## FINAL STRUCTURAL ENGINEERING COMPLIANCE CERTIFICATE

Re: Lot 1039 Oxford Falls Road - Modification of DA 2006/0339 to Modify Car Parking Configuration.

Figure 1 – Proposed car parking layout.

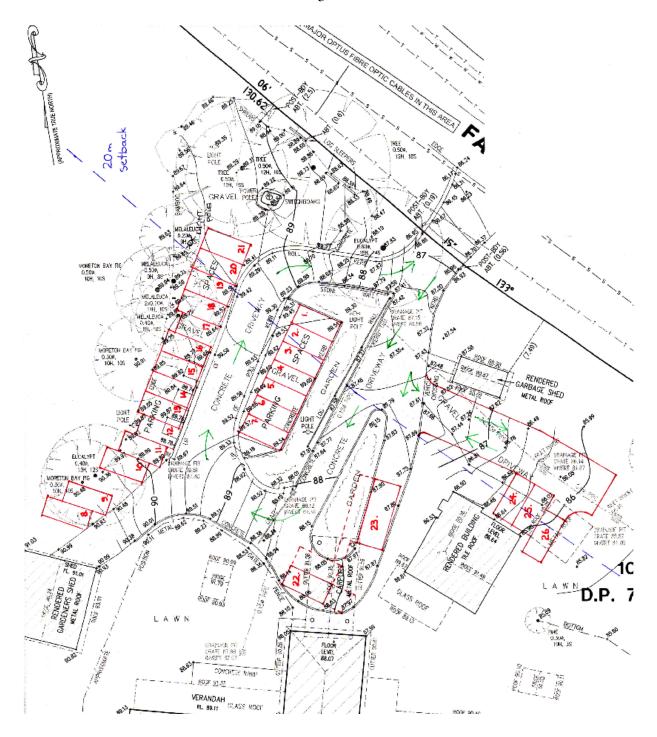
Car spaces 22 & 23 and the associated driveway (from Mod2011/2069) are to be deleted. These are to be moved to the proposed locations of disabled car spaces 22 & 23.

Reason: previously approved disabled car spaces will not be compliant due to the gradient of the approaching driveway. The dotted areas adjacent proposed car spaces 22 & 23 (not to be marked) indicate the shared areas required by AS 2890.6.

Car spaces 8 - 10 (from Mod 2011/0269) are to have their angles reconfigured and car space 26 is to be deleted. These are proposed to become spaces 8 - 11.

Reason: the angle of parking needs to change to avoid the adjacent trees & the area can then accommodate 4 rather than 3 car spaces.
